Flight Procedures Cover Page	Task Action: FLIGHT CHECK	Task Type: IAP	Estimated Chart Date: 08/10/2023	APWS Task ID: A040A65E79EA4C48A77D8E3F566D89AA	APWS Project ID: ED6440C158D84FF0B43726F72CA4391C
Procedure: ILS OR LOC RWY 7R AMDT 5		Enroute: NO	Specialist: Schones, Christopher		Agreement Number:
Airport ID: PANC			Airport City: ANCHORAGE		State: AK
Facility ID: ANC	Facility Type: ILS	Flight Inspection Remark Type: New FC Slot			
Procedure Comments: PANC active airport data used. I-ANC active data used. Contact Casimir Tabaka: 405-954-7931 QUALITY 20 CHECKED QUALITY 41 CHECKED

Memorandum

Subject: Approval Request: TED STEVENS ANCHORAGE INTL (PANC), ILS OR LOC
RWY 7R

ILS OR LOC RWY 7R
TED STEVENS ANCHORAGE INTL ANCHORAGE AK (PANC)

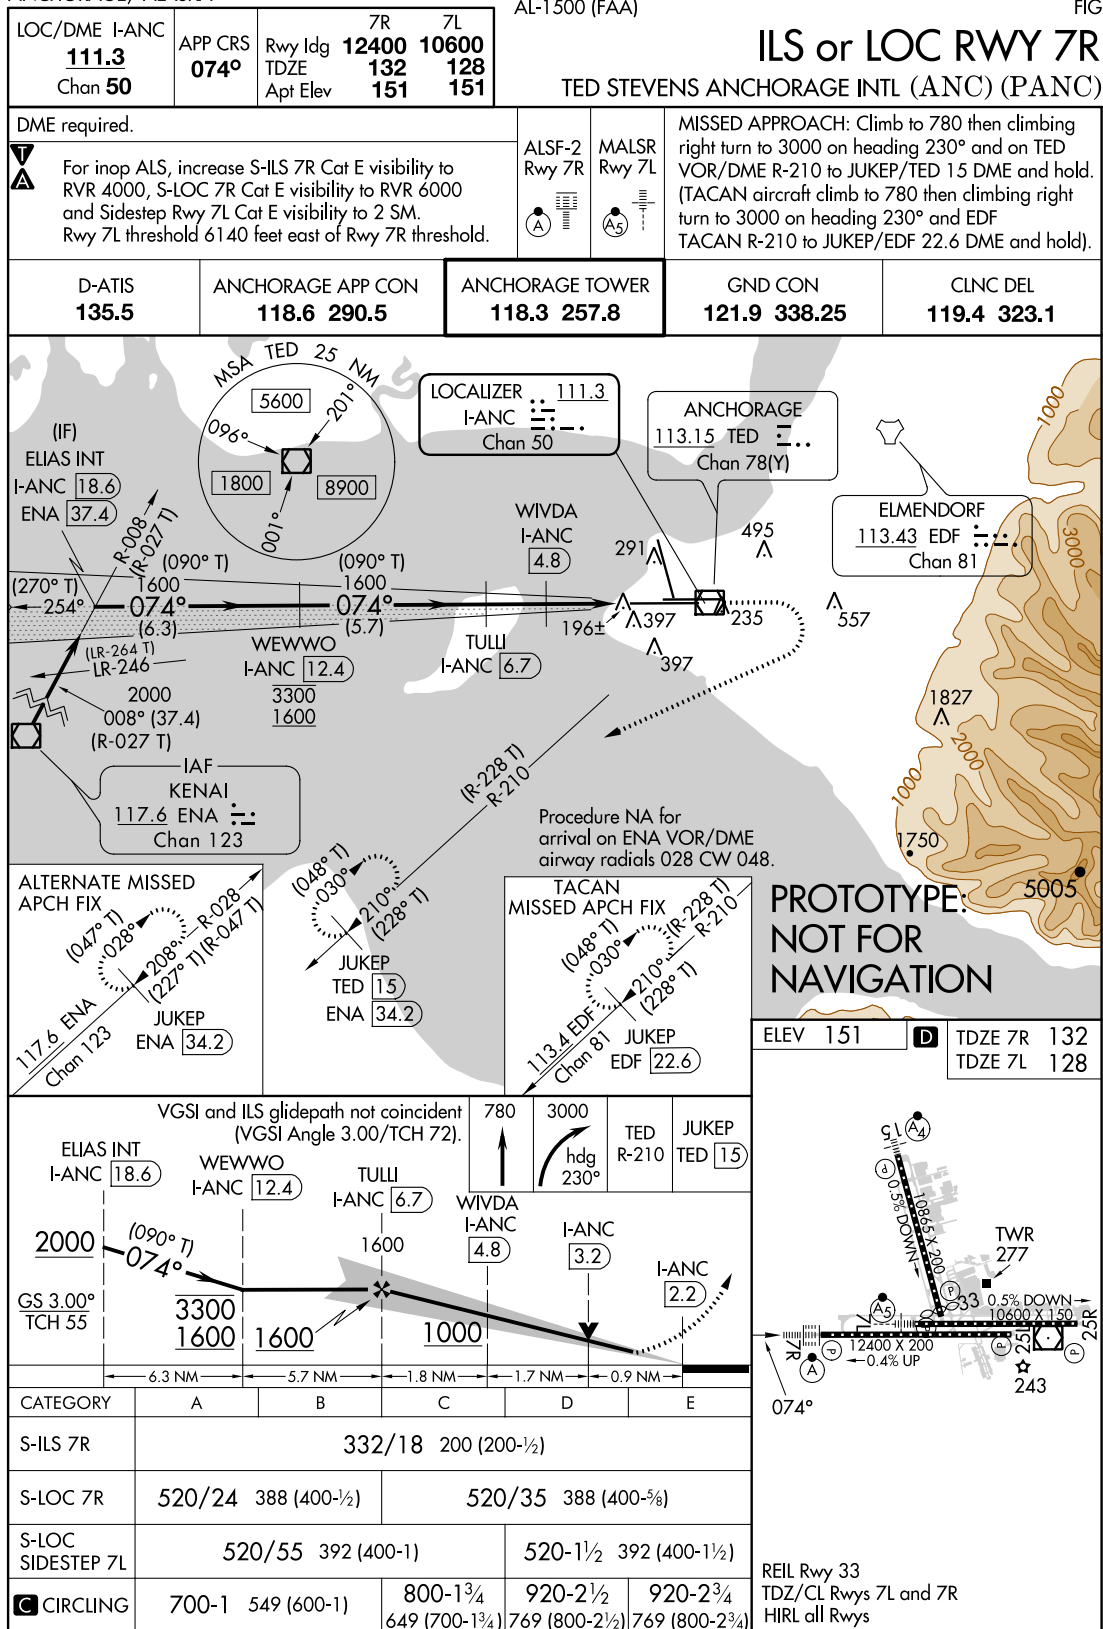
Request approval to establish block altitude on the intermediate stepdown fix due to operational requirement at ATC's request (FAAO 8260.19I). WEWWO was added to the approach due to wake turbulence. A block altitude is required to alleviate flow issues.
